CITY of NOVI CITY COUNCIL

SUBJECT: Final approval of the request of Keford Collision and Towing, JSP 18-31, with Zoning Map Amendment 18.725, to rezone property in Section 15, located on the south side of Grand River Avenue, east of Taft Road, from I-1 (Light Industrial) to I-2 (General Industrial) with a Planned Rezoning Overlay (PRO) Agreement and corresponding Revised PRO Concept Plan. The property totals 7.61 acres and contains two existing buildings. The applicant proposes to reuse the larger building for an auto body collision repair shop with accessory car rental services, and use the rear portion of the property as a vehicle tow yard. The applicant is proposing an additional amendment to the Concept Plan which is to allow the rear tow yard for up to 160 vehicles to be constructed with a gravel surface instead of the required hard pavement surface as previously shown.

TO: JEFF HERCZEG, DIRECTOR OF PUBLIC WORKS
FROM: KATE RICHARDSON, EIT; PLAN REVIEW ENGINEER
SUBJECT: VARIANCE REQUEST FOR KEFORD TOWING
DATE: MAY 23, 2019

PRO CONCEPT PLAN

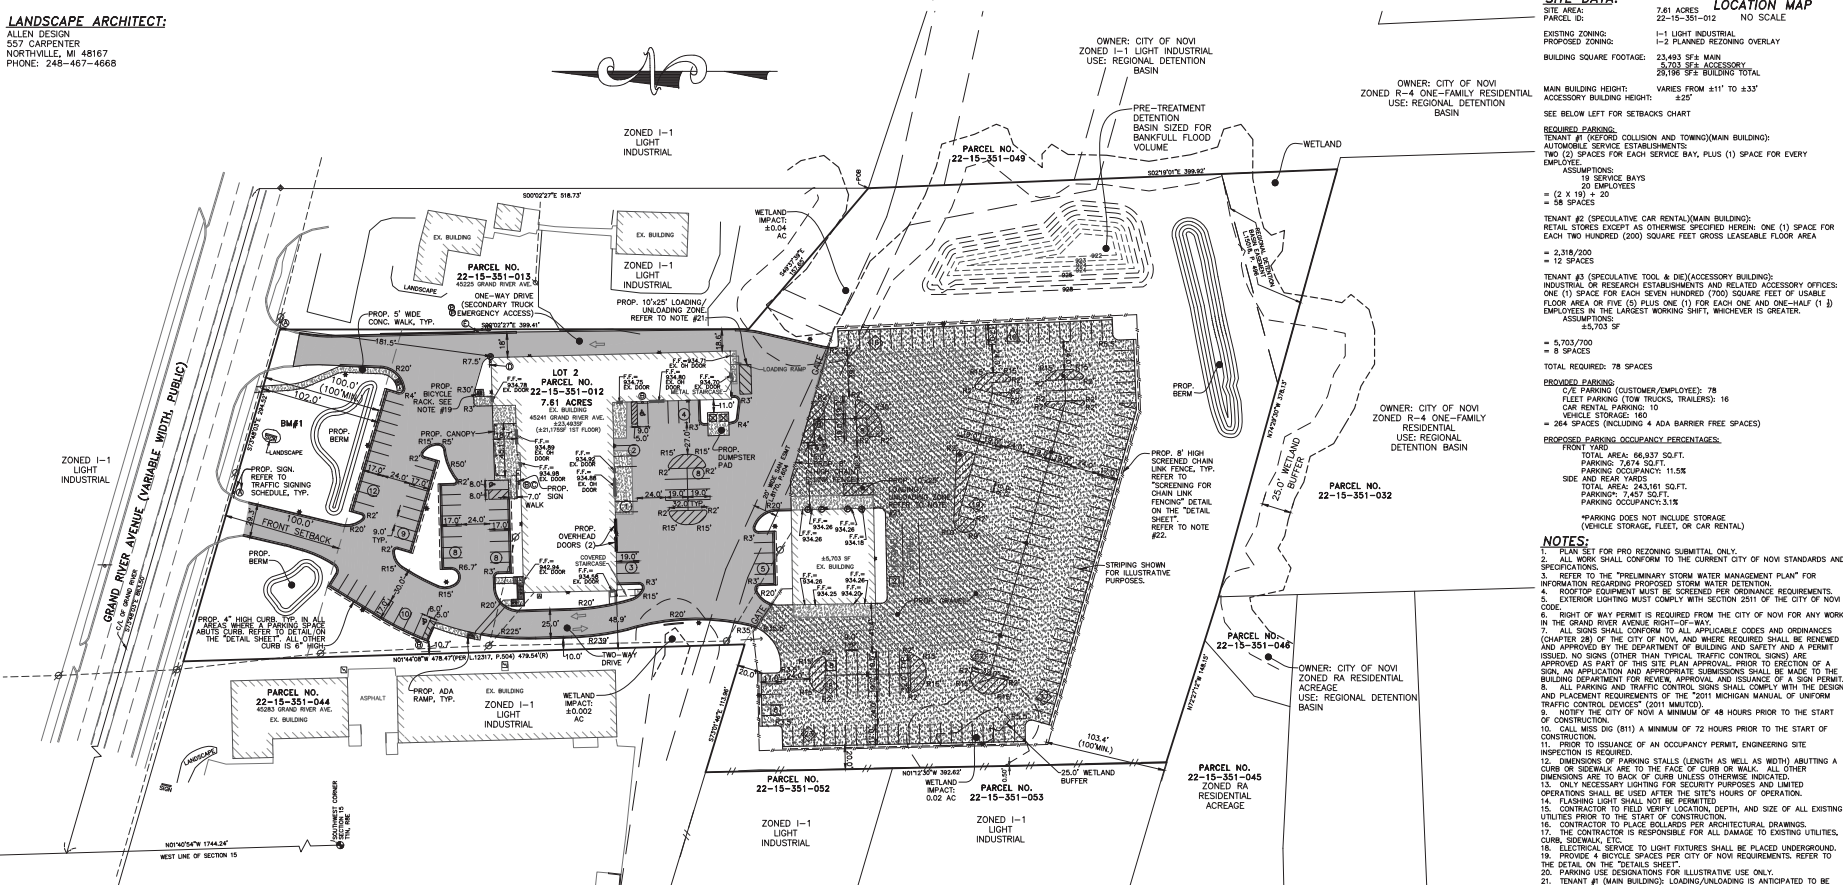
The applicant has now proposed a change to the PRO Concept Plan to allow the 160-space rear yard vehicle storage area to have a gravel surface instead of the required asphalt. This plan change would require the following additional deviations:

The City requires parking lots to be paved and curbed as outlined in Section 11-239 of the Design and Construction Standards. The revised Concept plan proposes gravel parking for storage yard in the rear. The applicant has provided a detailed narrative listing the reasons for the request. As noted in the narrative, based on the construction costs and geo-technical studies that the request is made primarily because it is 'not only extremely expensive to build initially but also is virtually impossible to maintain in a paved state given the intended use.' **Planning, Engineering, and Traffic have provided the following reasons to recommend denial.**

Staff has reviewed the application against the Ordinance standards that are outlined above. We disagree with the applicant's engineer that the proposed gravel surface is adequate for the intended use and does not substantially deviate from the performance of the ordinance standard cross-section. A hard-surfaced pavement is required to provide a stable surface that is resistant to rutting and wear and is strong enough to support the proposed use by heavy vehicles. The applicant has not provided

data to support the assertion that the proposed gravel is comparable in strength to the ordinance requirements and capable of supporting 35 tons for emergency vehicles (as required in section 11-239(b)(5)). We also noted that the plan shows delineated parking stalls, however it would not be possible to apply pavement markings without a paved surface.

Based on the Wetland Review letter by the City's Wetland Consultant, the applicant's plan shows that the property contains three City regulated wetlands. Curb, gutter and storm catch basins are not proposed on the plan to guide and direct the flow of storm water within the gravel parking area. Instead, the applicant is proposing to sheet flow the parking lot drainage into the detention basin. Based on past experience, staff has concerns with the sheet flow of large areas of parking lot because of the erosion that will likely occur at the edge of the parking area. The lack of pavement to stabilize the surface of the proposed parking area increases the concern for erosion of material from the parking lot and sedimentation of not only the detention basin, but transport and deposition of suspended solids into the adjacent wetlands that receive the flow from the detention basin. We have some concerns with the use of gravel as a surface material because of the oil and/or gas that could leak from vehicles requiring maintenance. These pollutants could potentially leach into the adjacent wetland areas and groundwater. For these reasons, we believe that granting the variance would be detrimental to public health and could negatively impact wetlands on adjacent properties.

A concern was also stated regarding the handicap parking spot which is located to the east of the small building within the fenced-in lot. The attached revised sheet 1 of the Concept Plan shows that this handicap spot will be asphalt and striped with the necessary adjacent access area. This space will not be used to park damaged vehicles awaiting repair and that space will be asphalt.

The attached revised sheet number 1 of the Concept Plan also addresses where the towing vehicles will be parked. Keford Collision has 15 tow-trucks and two large towing trailers. The trailers will be parked, while not in use, on the south side of the small building inside of the rear fenced-in parking lot. Those two spaces are clearly marked on sheet 1 of the concept plan as "trailer". The attached revised sheet number 1 of the Concept Plan also depicts parking spaces within the rear fenced-in lot. There are numbers within each row of parking spaces which totals the number of parking spaces within that row. Some of those numbers are surrounded by squares and some of the numbers are surrounded by diamonds. Those parking rows with the number surrounded by squares are the parking spaces for the tow-truck vehicles. Thus, this depicts where those vehicles will be parked. Indeed, under the "site data" on sheet number 1, particularly under "provided parking" you will see that there are 17 spaces for "fleet parking" Please note also, in any given day there are an average of 5 tow-trucks and one trailer out on the road and not in the lot. During the night time hours there are an average of two trucks out on the road.
